<b>Title - Sujet</b> Health Care Expansion	
<b>Solicitation No. - N° de l'invitation</b> EZ899-181607/A	<b>Amendment No. - N° modif.</b> 005
<b>Client Reference No. - N° de référence du client</b>	<b>Date</b> 2017-12-15
<b>GETS Reference No. - N° de référence de SEAG</b> PW-\$PWY-025-8228	
<b>File No. - N° de dossier</b> PWY-7-40258 (025)	<b>CCC No./N° CCC - FMS No./N° VME</b>
<b>Solicitation Closes - L'invitation prend fin</b> <b>at - à 02:00 PM</b> <b>on - le 2017-12-22</b>	
<b>F.O.B. - F.A.B.</b> <b>Plant-Usine:</b> <input type="checkbox"/> <b>Destination:</b> <input checked="" type="checkbox"/> <b>Other-Autre:</b> <input type="checkbox"/>	
<b>Address Enquiries to: - Adresser toutes questions à:</b> Fung, Donna(PWY)	<b>Buyer Id - Id de l'acheteur</b> pwy025
<b>Telephone No. - N° de téléphone</b> (604) 671-9689 ( )	<b>FAX No. - N° de FAX</b> (604) 775-6633
<b>Destination - of Goods, Services, and Construction:</b> <b>Destination - des biens, services et construction:</b> CSC - Mountain Institution - Agassiz, BC

This Amendment No. 005 is raised to:

Healthcare Expansion  
Mountain Institution, Agassiz, BC

**Solicitation No: EZ899-181607/A**

Drawing title/Titre du dessin  
**EXTENT OF WATERPROOFING**

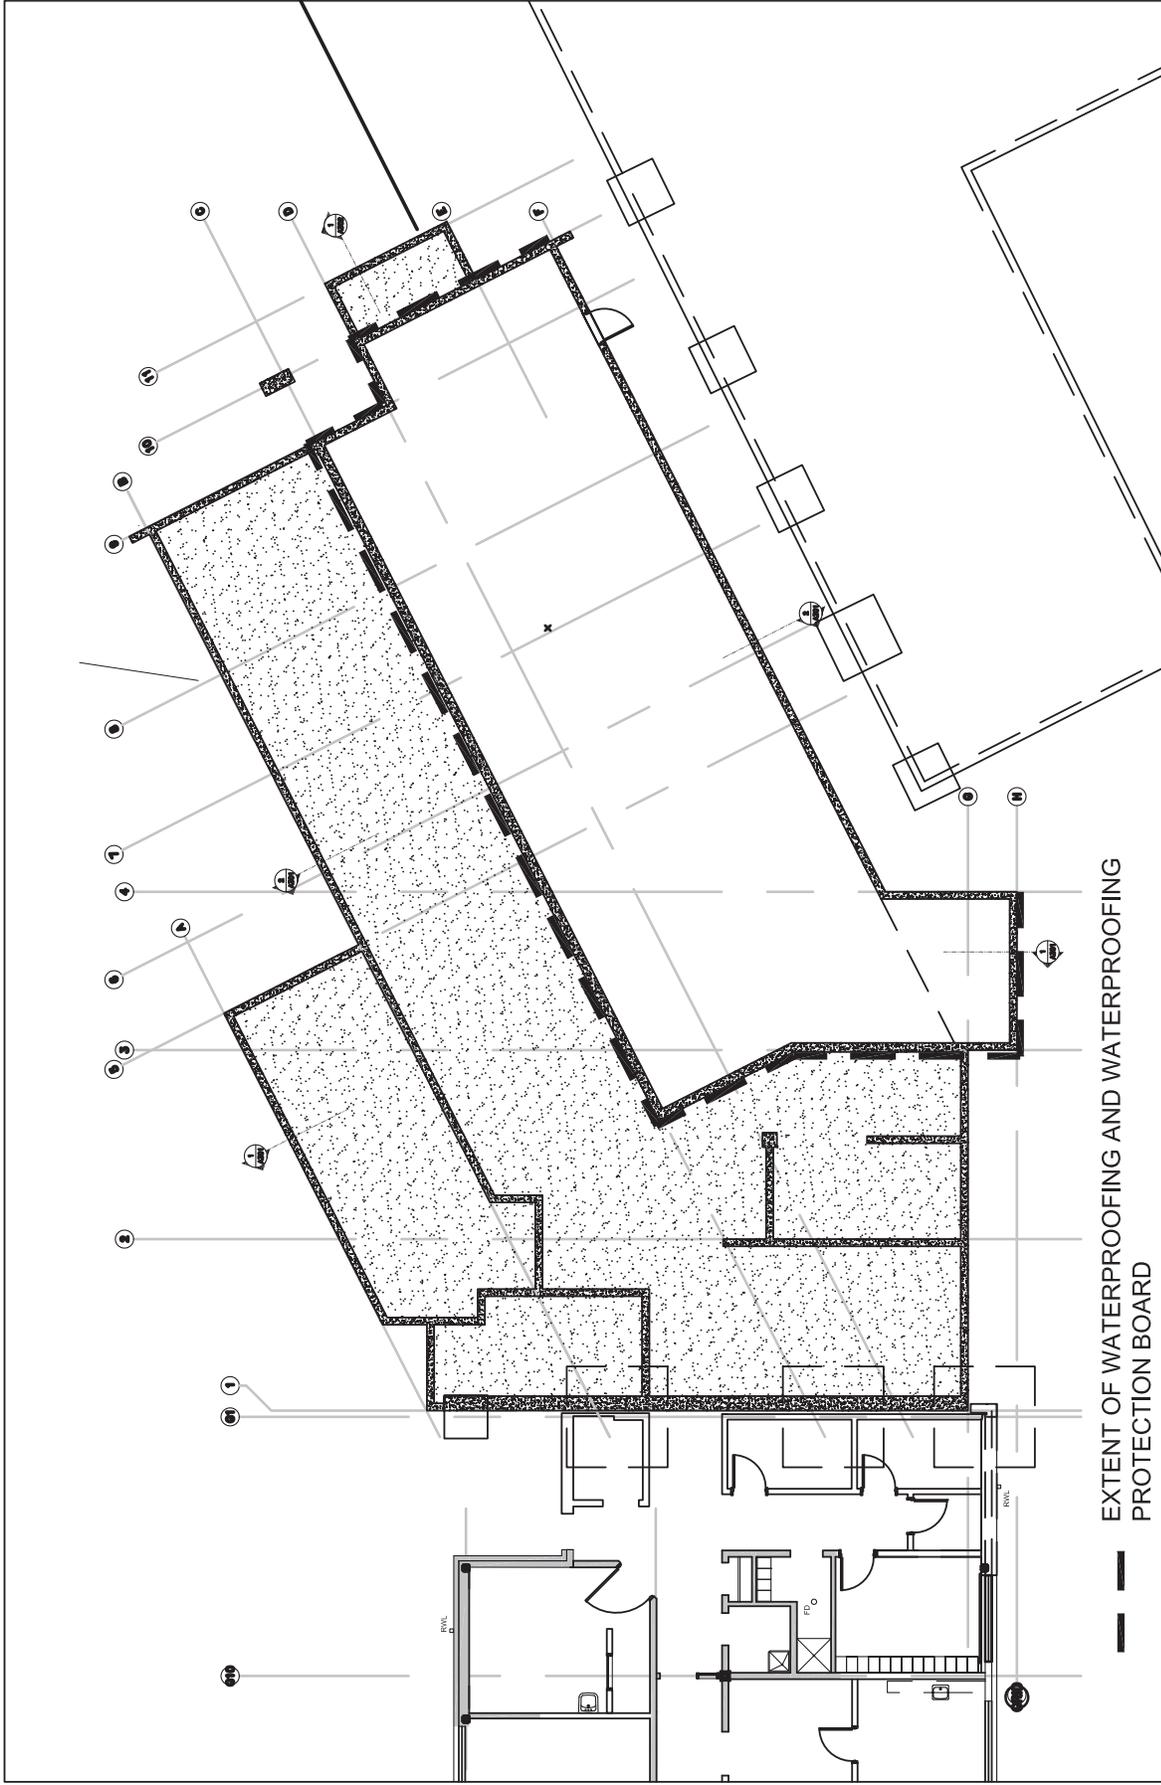
7. Question: Please provide the information for the following items. Modified bituminous waterproofing is shown only for wall between crawl space and Slab on grade wall. If other basement walls will not be applied with bituminous waterproofing.

- Answer: See ASK-01 issued in Addendum #02 for full extent of waterproofing. Provide protection board for all waterproofing. Where waterproofing occurs not under a slab, step down waterproofing to maintain adequate coverage by grade per manufacturer's recommendations.

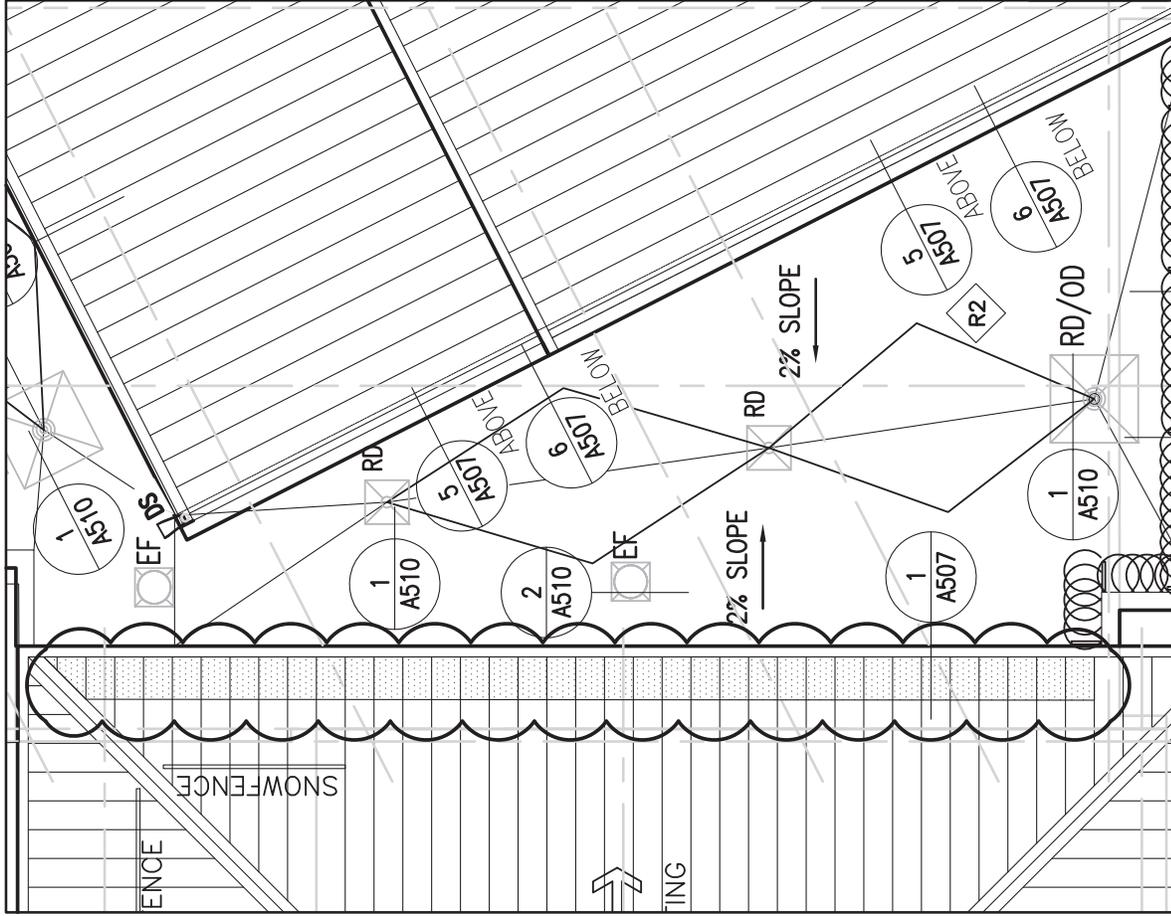
- .1 A110 ROOF PLAN
  - a) **[Revise]** Roof plan per bubbled area on ASK-02
- .2 A507 SECTION DETAILS 1
  - a) **[Replace]** Detail 01/A507 with ASK-03, complete.

CUT BACK EXISTING METAL ROOF, MODIFY  
EXISTING ROOF ASSEMBLY, SEE DETAIL 1/A507

CORRECTIONAL SERVICE  
OF CANADA  
Project title/Titre du dessin  
1/A507 REVISED ROOF DETAIL  
Project title/Titre du dessin  
4732 CEMETERY ROAD PO BOX 1600  
MOUNTAIN INSTITUTE  
HEALTH CARE EXPANSION

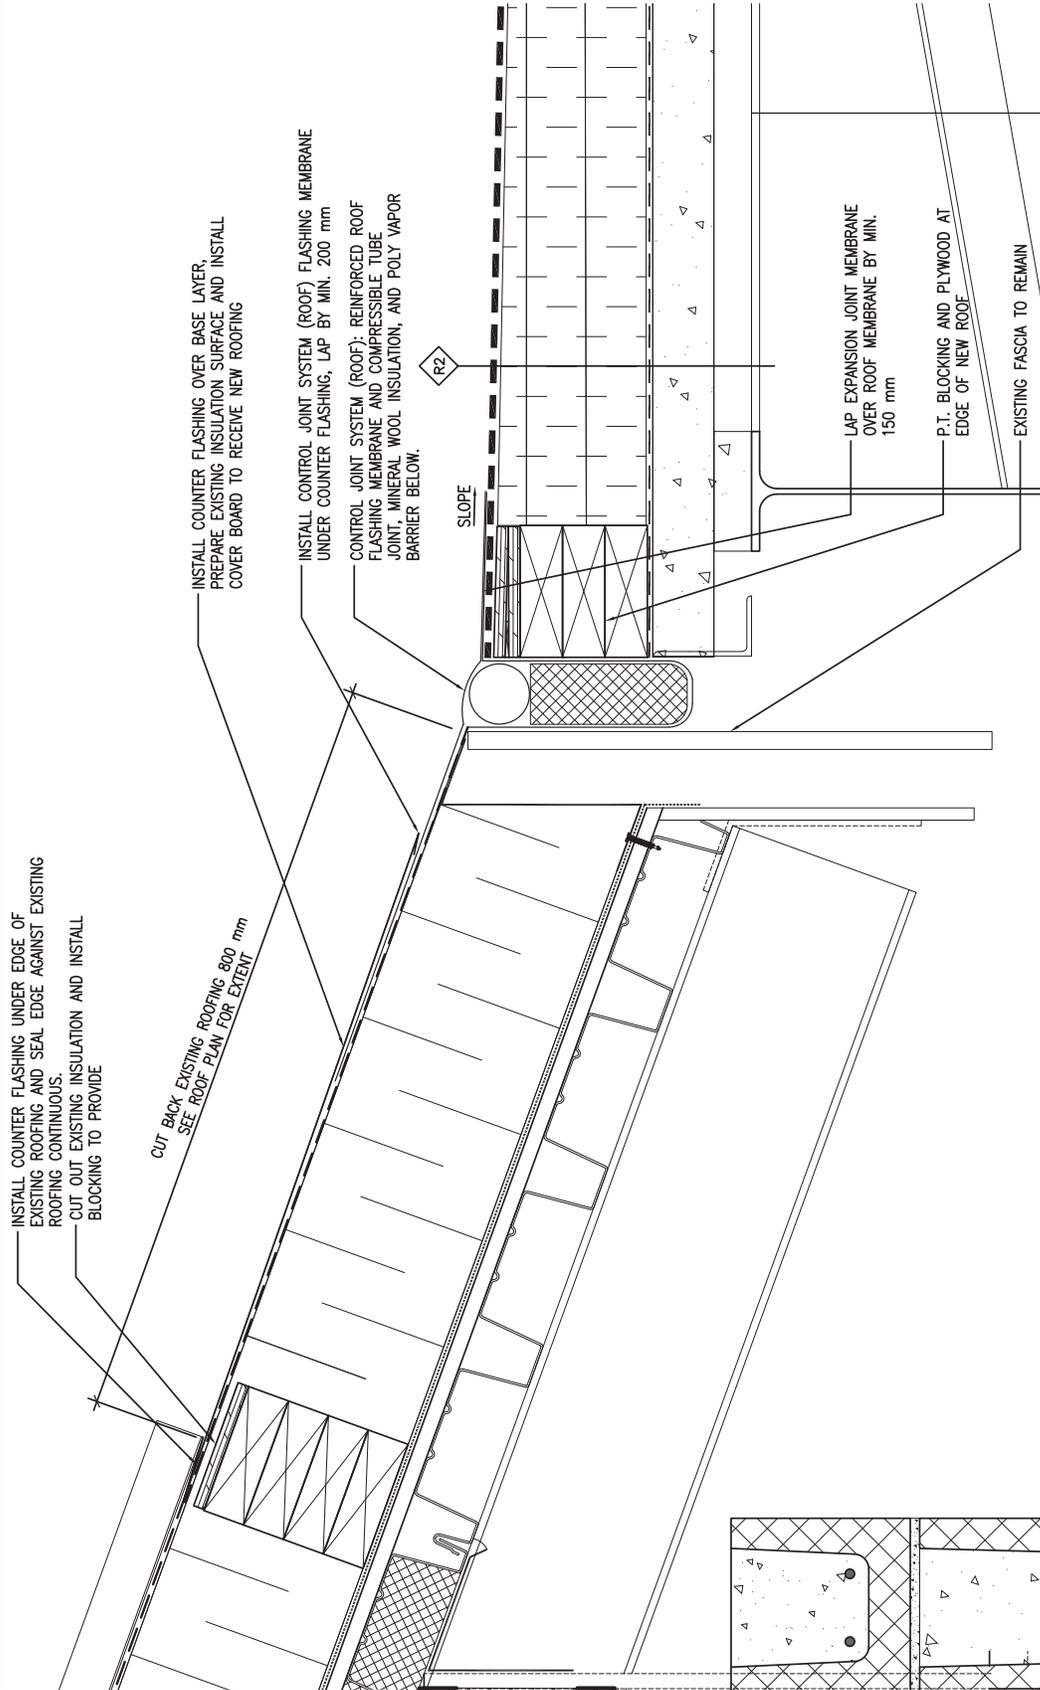
INSTALL COUNTER FLASHING UNDER EDGE OF  
EXISTING ROOFING AND SEAL EDGE AGAINST EXISTING  
ROOFING CONTINUOUS.  
CUT OUT EXISTING INSULATION AND INSTALL  
BLOCKING TO PROVIDE

Cut Back Existing Roofing 800 mm  
SEE ROOF PLAN FOR EXTENT

INSTALL COUNTER FLASHING OVER BASE LAYER.  
PREPARE EXISTING INSULATION SURFACE AND INSTALL  
COVER BOARD TO RECEIVE NEW ROOFING

INSTALL CONTROL JOINT SYSTEM (ROOF) FLASHING MEMBRANE  
UNDER COUNTER FLASHING, LAP BY MIN. 200 mm  
CONTROL JOINT SYSTEM (ROOF): REINFORCED ROOF  
FLASHING MEMBRANE AND COMPRESSIBLE TUBE  
JOINT, MINERAL WOOL INSULATION, AND POLY VAPOR  
BARRIER BELOW.
